ADDENDUM NO. 1**NEBRASKA AVENUE WATER MAIN REHABILITATION
COUNCIL BLUFFS WATER WORKS
July 31, 2026**

Project: **NEBRASKA AVENUE WATER MAIN REHABILITATION**
Council Bluffs Water Works
Snyder & Associates, Inc. Project No. 125.1319.01

CONSTRUCTION PLANS FOR
NEBRASKA AVENUE WATER MAIN REHABILITATION
COUNCIL BLUFFS WATER WORKS
COUNCIL BLUFFS, IOWA

Sheet B.2

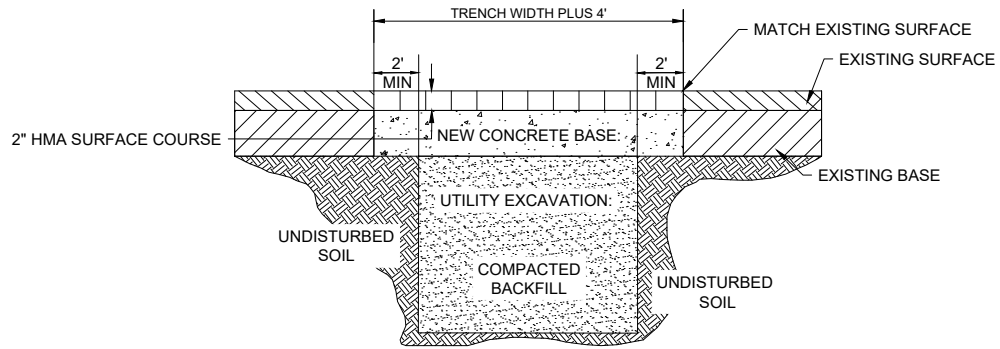
16. Please confirm that subgrade prep/treatment will not be needed in the access pit restoration. Assumed underlying soils are sand. Without Geotech information, contractors will not be able to responsively know what is needed for this work other than to assume the worst. – **detail added to plans with addendum.**

Project No: 125.1319.010
Sheet D.1

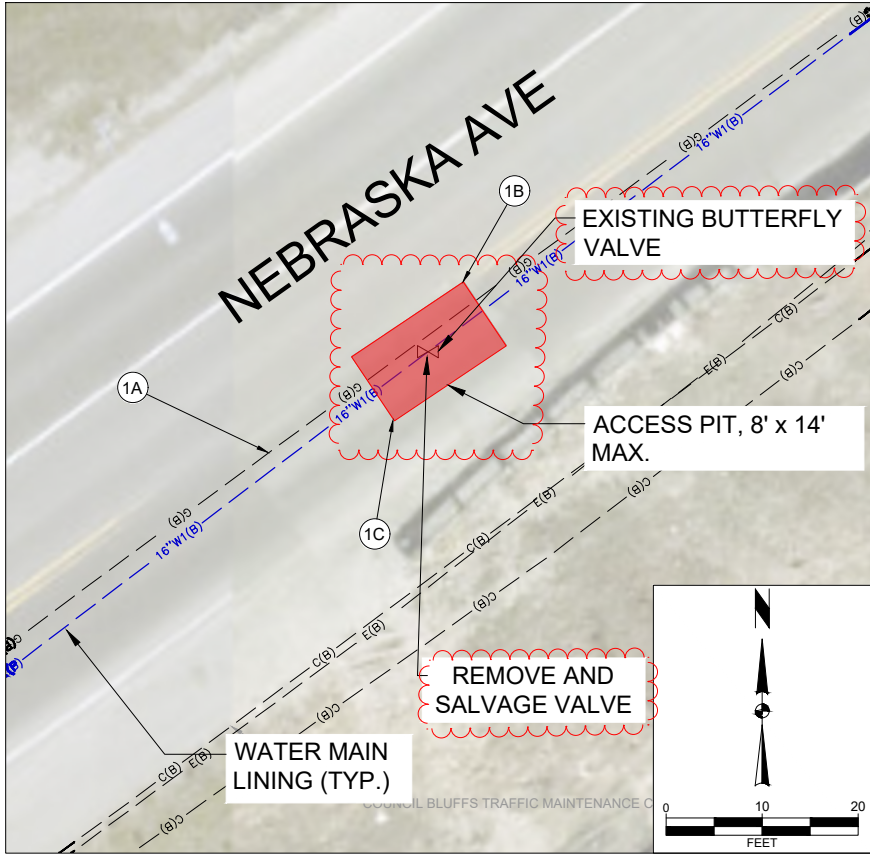
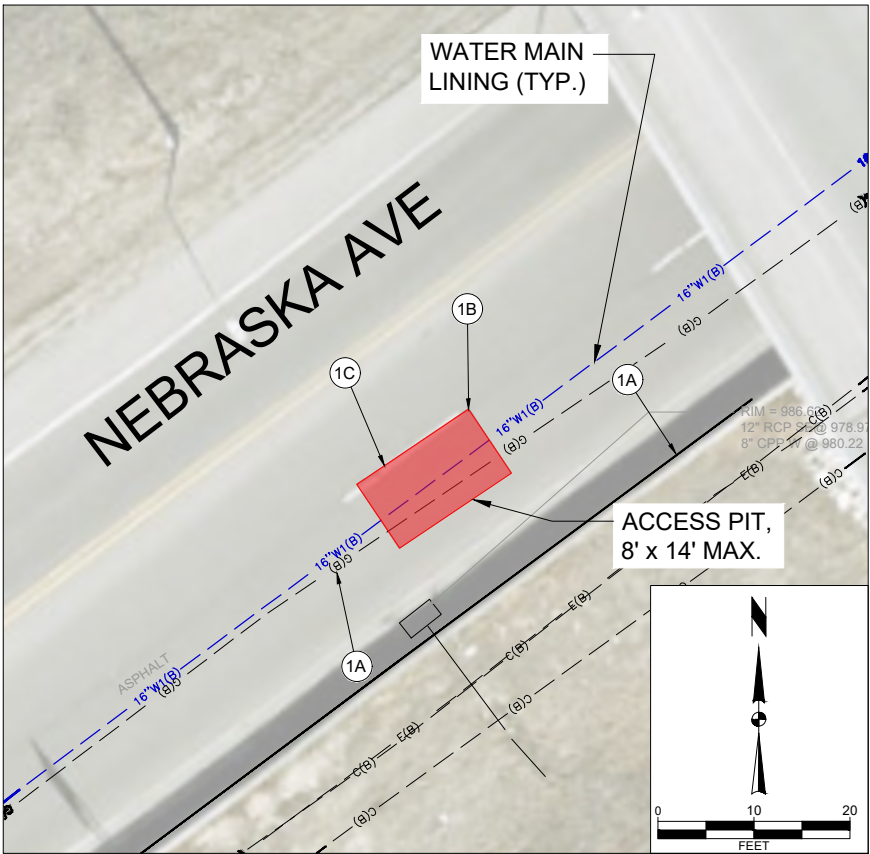
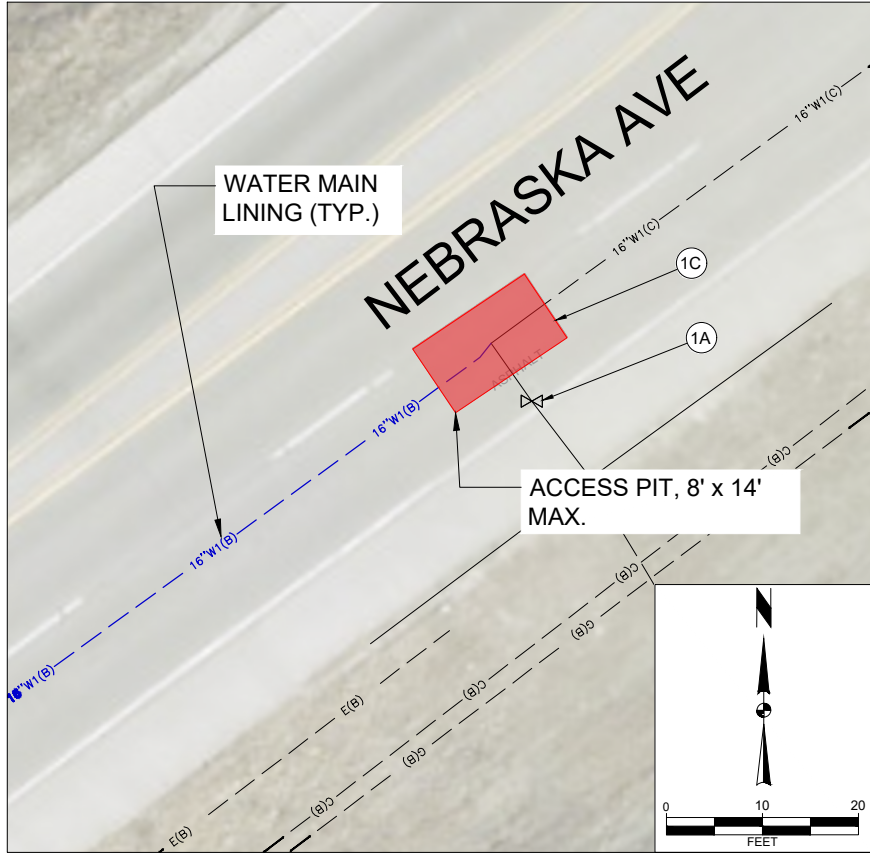
10. Sheet D.1 – Detail 1/D.1 – The 8” line heading north out of the access pit #1 does not appear to have a gate valve beyond the tee. How will this line be isolated during the execution of the Work? – **Valve near street light at intersection. This is a service line. Casino is end user.**

Sheet J.1

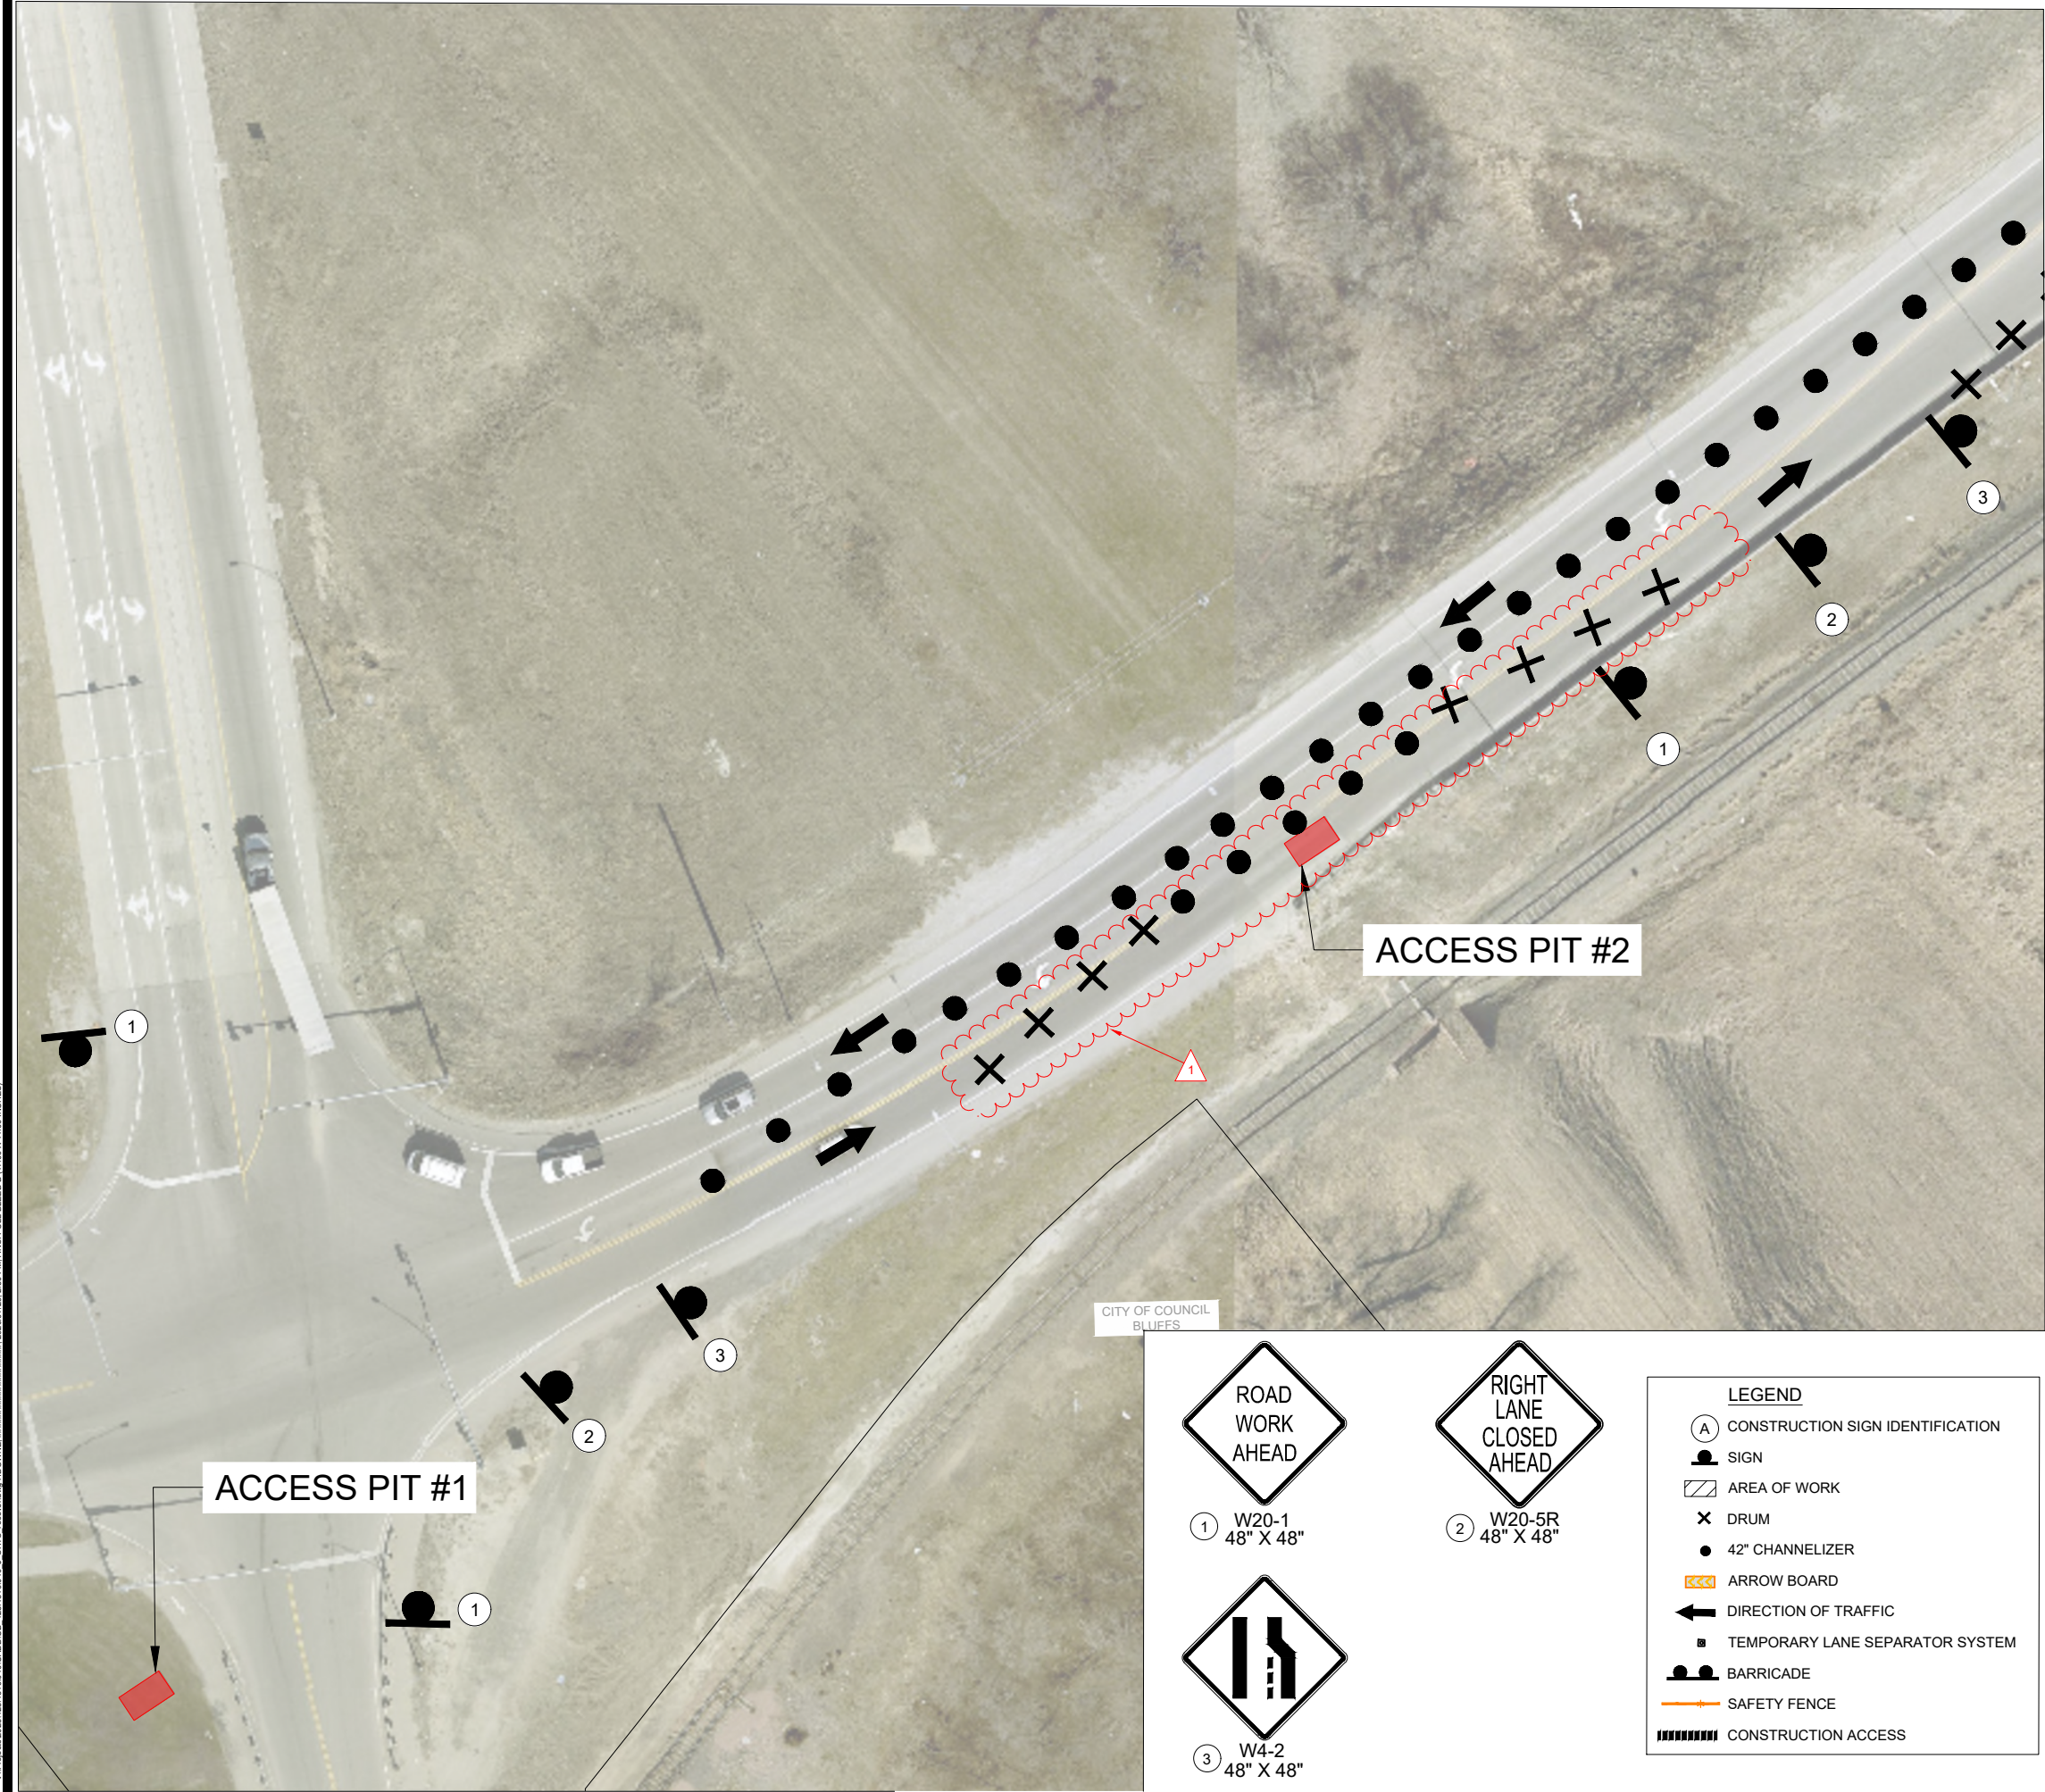
11. Sheet J.1 – On the SW quadrant of River/Nebraska, we will need to close the sidewalk and partial lane around the radius. Please revise the traffic control plan to reflect this. – **One lane of traffic each direction must be maintained during the project. Refer to Note 10, Sheet J.1 for sidewalk closure information.**

Sheet J.2

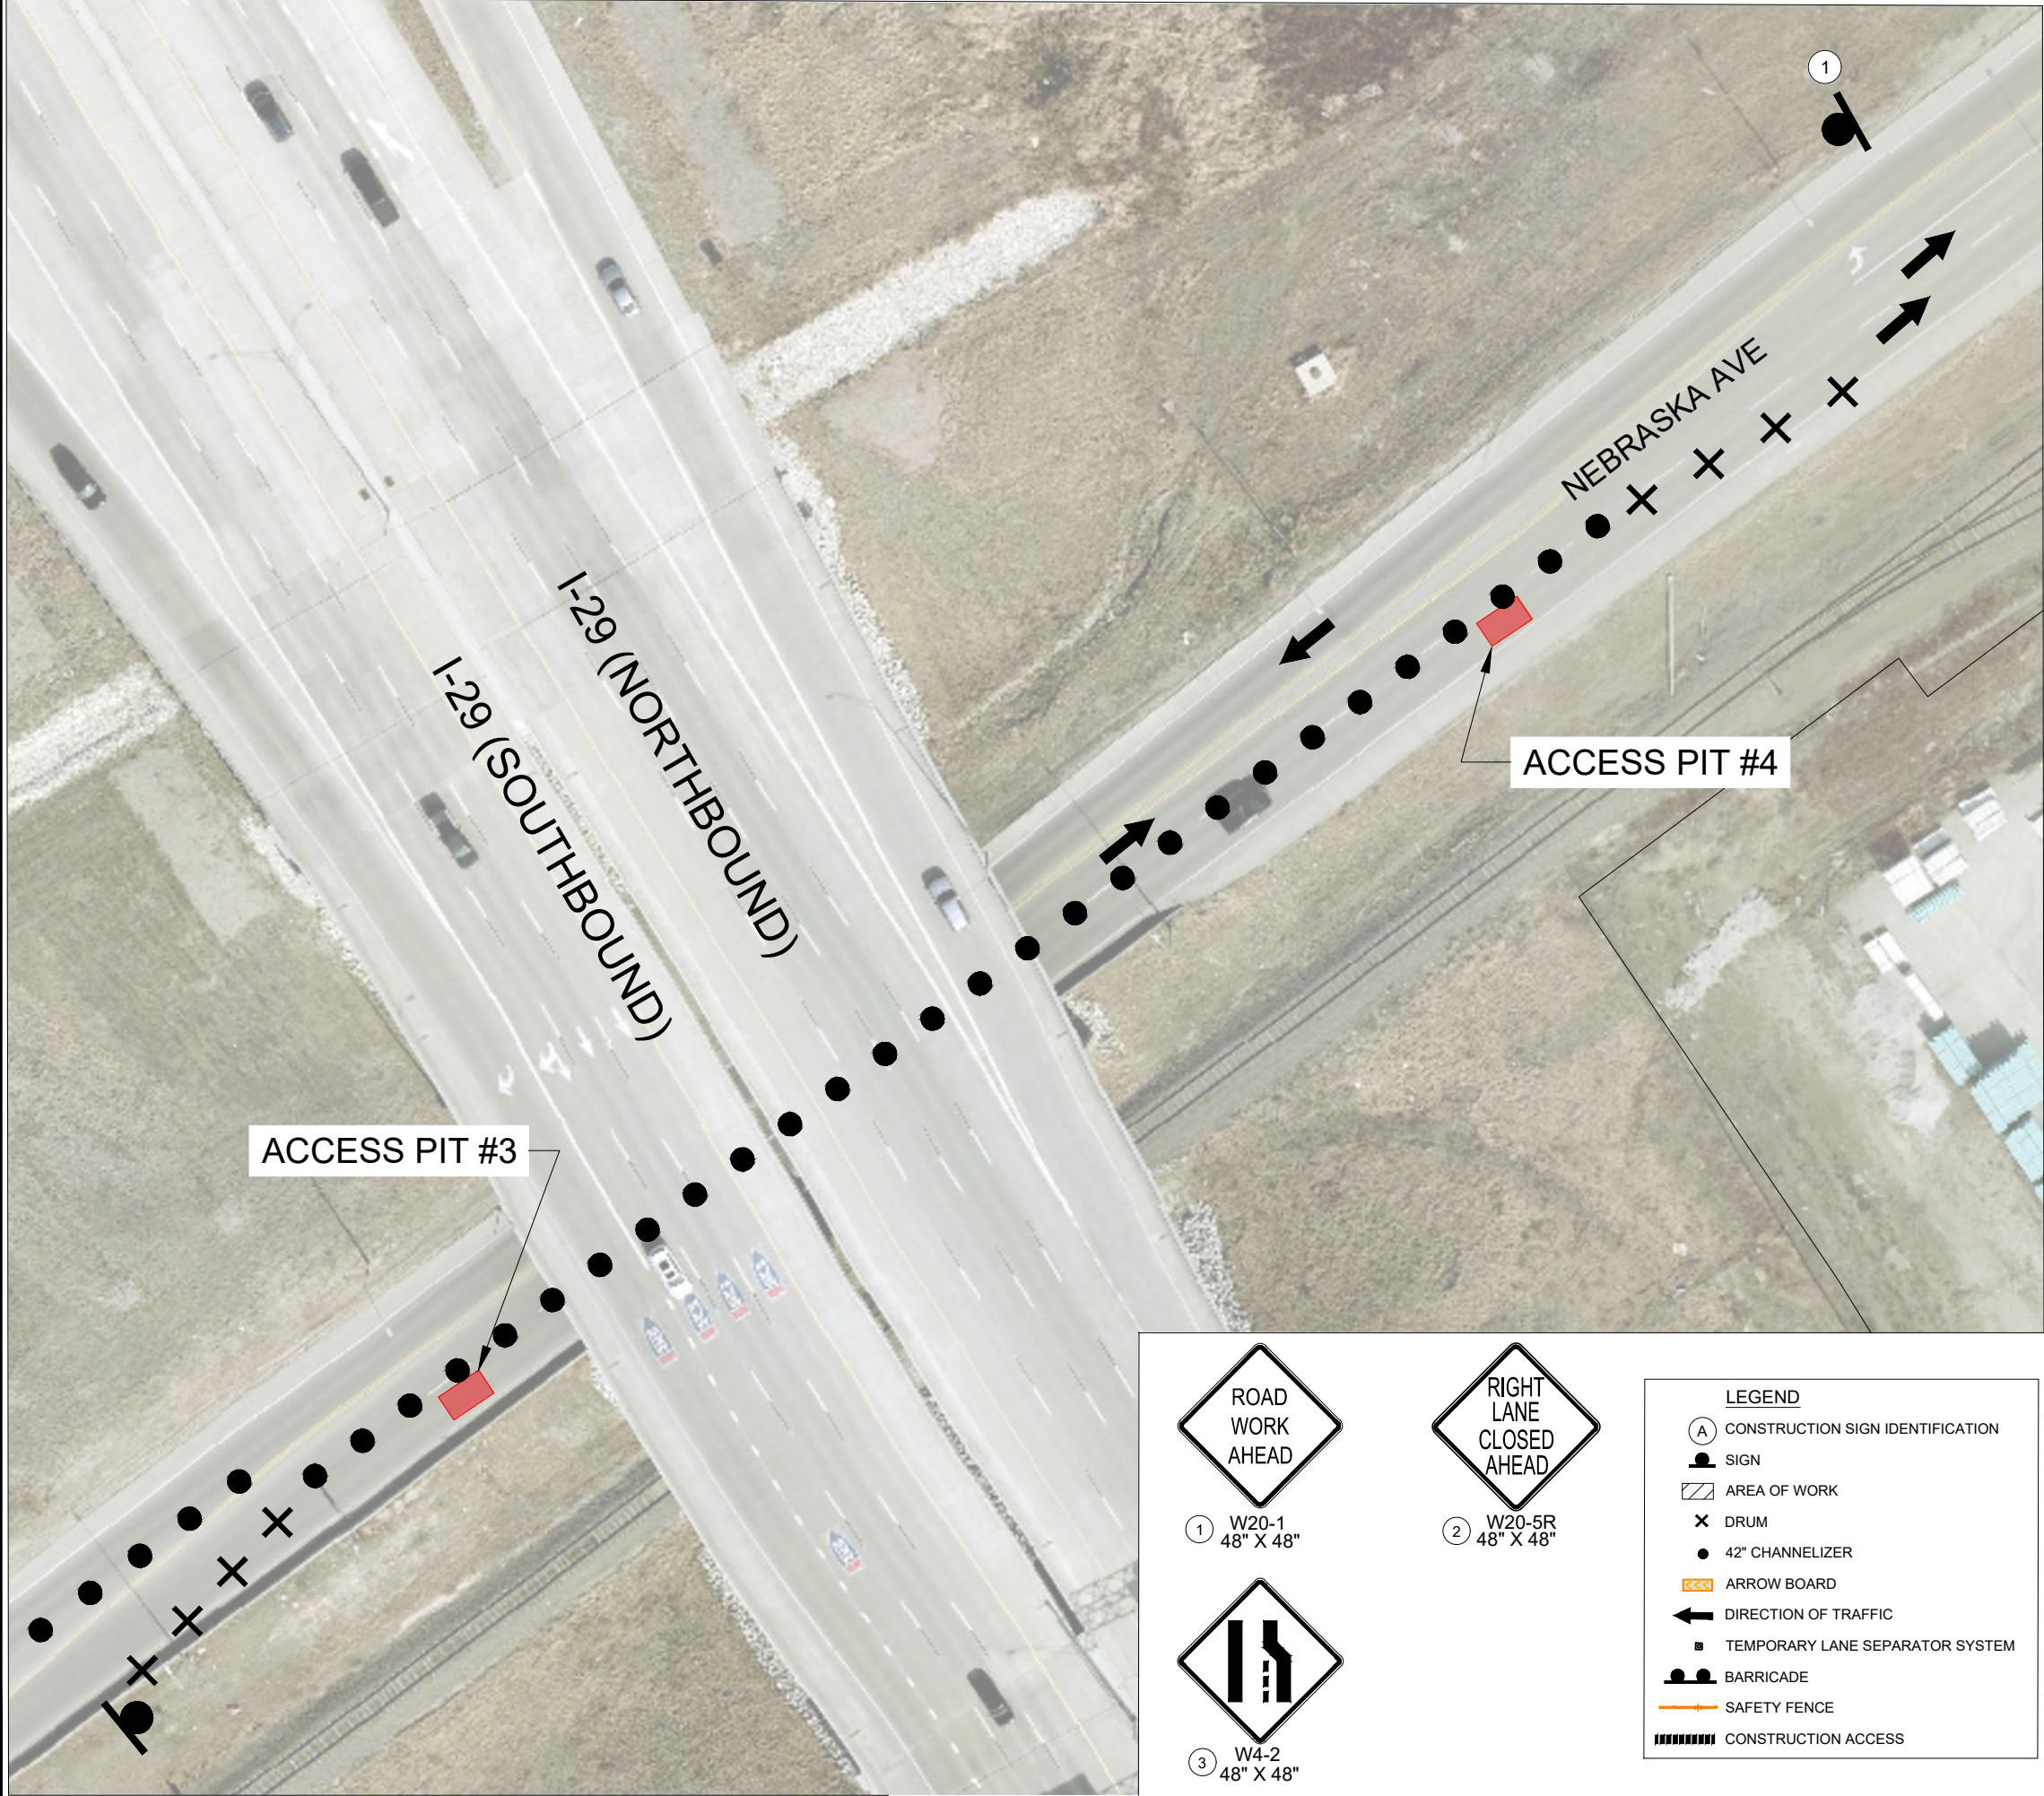
- △ 15. MESSAGE BOARDS SHOULD BE PUT IN PLACE A MINIMUM OF 72 HOURS PRIOR TO THE START OF CONSTRUCTION, WARNING OF THE UPCOMING CONSTRUCTION AND IDENTIFYING THIS AS A WATER WORKS PROJECT.
